# Access Compliance Report Public Rights-of-Way (Curb Ramps)

Main Street: N/A Cross Street: MERCANTILE\_WAY Location: S

ADA ID: RPRK211029122153 Ramp Type: Type 4 - Parallel Initial Pass/Fail: Fail Overall Compliance: No Severity Score: 2

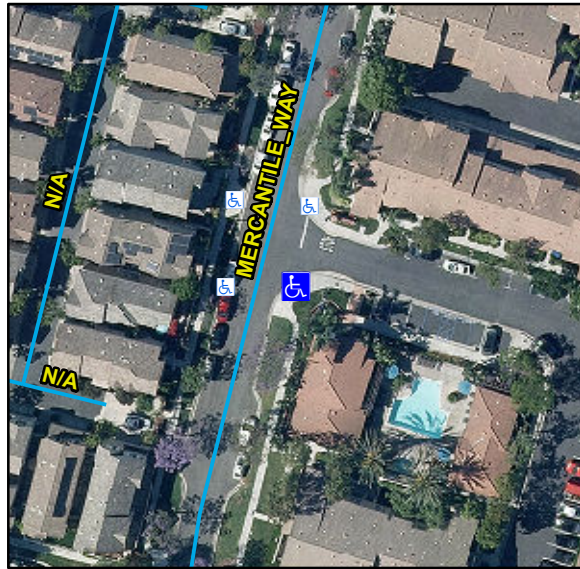
R304.2.2, R204.3, R304.5.3, STD 1115

| Compliance | Description                   | Data       | Compliance | Description                   | Data |
|------------|-------------------------------|------------|------------|-------------------------------|------|
| Yes        | Ramp Cross Slope LT (%)       | 0.8        | No         | Ramp Cross Slope RT (%)       | 3.8  |
| N/A        | Gutter Ponding                | N/A        | No         | Curb Slope                    | 13.2 |

Remove & Replace Curb Ramp With Two New Directional Ramps or Equivalent.
